**Economic Commission for Europe****Inland Transport Committee****World Forum for Harmonization of Vehicle Regulations****Working Party on Passive Safety****Forty-eighth session**

**Regulation No. 14 (Safety-belt anchorages)****Proposal for Supplement 2 to the 07 series of amendments****Submitted by the experts from Belgium and Germany\***

The text reproduced below was prepared by the experts from Belgium and Germany in order to introduce prescriptions for side-facing seats in vehicles of category M<sub>3</sub> (Class II, III and B). This proposal supersedes ECE/TRANS/WP.29/GRSP/2010/24. The modifications to the current text of the Regulation are marked in bold for new or strikethrough for deleted characters.

Figure 1b

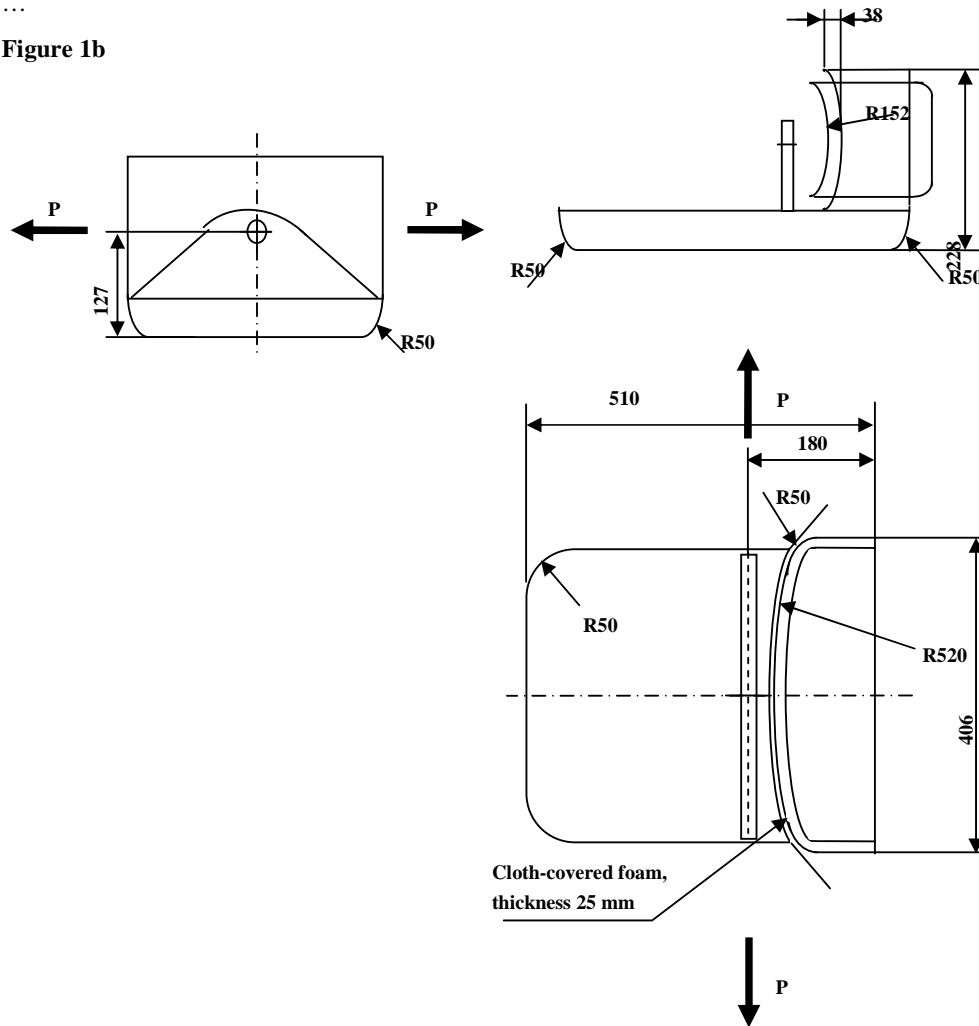
- 6.4.7.3. Traction device adapted for the test of side-facing seats is shown in Annex 5, figure 1b.
- 6.4.8. Test of the basic structure of side-facing seats

Annex 5, insert a new figure 1b, to read:
